World Forum for Harmonization of Vehicle Regulations

182nd session

Proposal for the 01 series of amendments to UN Regulation No. 35 (Foot controls)

Submitted by the Working Party on General Safety *, **

Annex 1, item 5, amend to read:

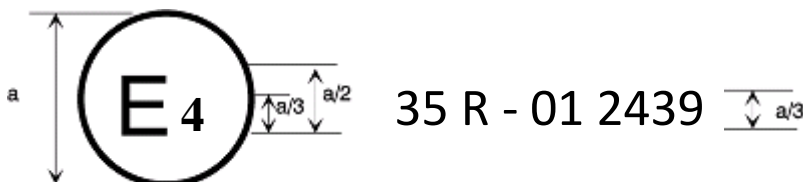
- "5. Brief description of the vehicle type as regards the arrangement of foot controls and foot rest....."

Model B

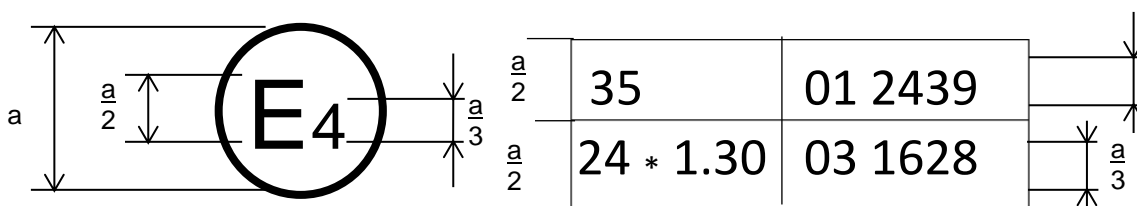
The above approval mark affixed to a vehicle shows that the vehicle type concerned has been approved in the Netherlands (E 4) pursuant to UN Regulation Nos. 35 and 24.¹ (In the case of the latter UN Regulation the corrected absorption co-efficient is 1.30 m⁻¹). The first two digits of the approval numbers indicate that, at the date on which the respective approvals were granted, UN Regulation No. 35 included the 01 series of amendments and UN Regulation No. 24 included the 03 series of amendments.

Figure 1a
Two pedals – Automatic transmission without footrest

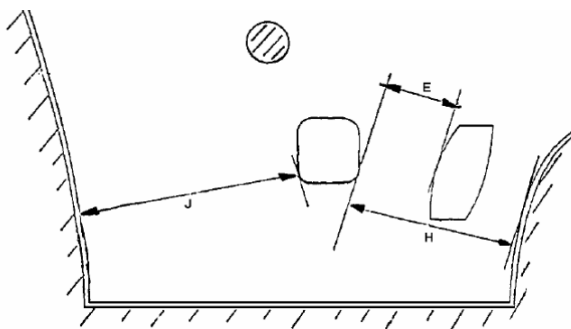
- "5.7. The distances, respectively shown as "H" and "J" in Annex 4, between the projection of the service-brake pedal on to the reference plane "P" and the intersection of each of the walls with that plane shall be ≥ 130 mm to the right and ≥ 160 mm to the left for vehicles with three pedals, and ≥ 130 mm to the right and ≥ 120 mm to the left for vehicles with two pedals.

Annex 4, amend to read:

Figure 1b
Two pedals – Automatic transmission with footrest

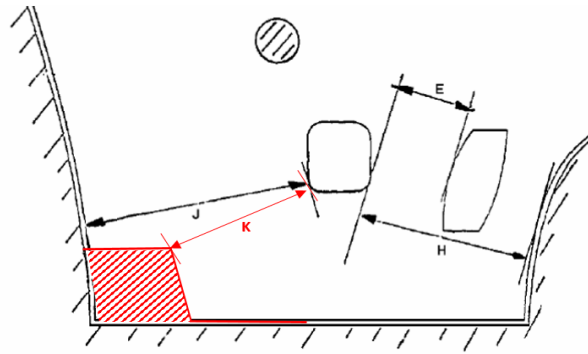
In the case of a foot rest as declared by the manufacturer, installed for the driver's left foot, the measurements for "J" and "G" in Annex 4 shall ignore the foot rest. The distance, shown at "K" in annex 4, between the contour points of the projection of the left most pedal on to plane "P" and the intersection of the footrest with plane "P" shall be ≥ 50 mm."

Figure 2a
Three-pedals – Conventional transmission without Footrest

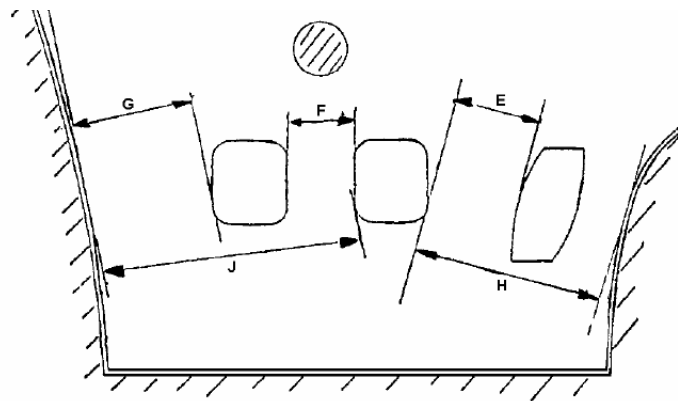
- "5.5. The distance, shown at "F" in annex 4, between the orthogonal projections of the service-brake-pedal and the clutch-pedal bearing surfaces on to the reference plane "P" shall be ≥ 50 mm."

- "5.6. The distance, shown at "G" in annex 4, between the contour points of the projection of the clutch pedal on to plane "P" and the intersection of the nearest wall with plane "P" shall be ≥ 50 mm."
